## 25V-799 WAY-105 Incorrect Cargo Carrying Capacity Label

**Purpose:** Replace incorrect OCCC label with a correct OCCC label.

**Models:** 2026 Open Trail Motorhomes

Figure 1

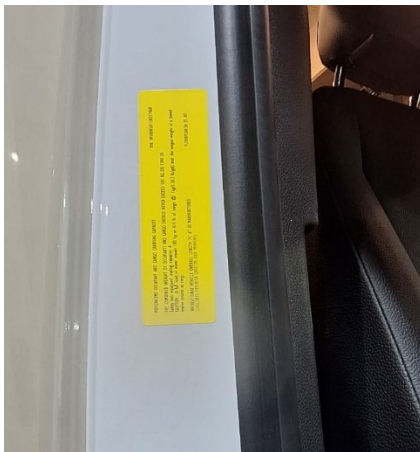
1. The yellow Cargo Carrying Capacity Label can be found on the driver's side door frame, Figure 1.
2. Wipe off the old label with isopropyl alcohol.
3. Carefully place the new label directly on top of the old label.
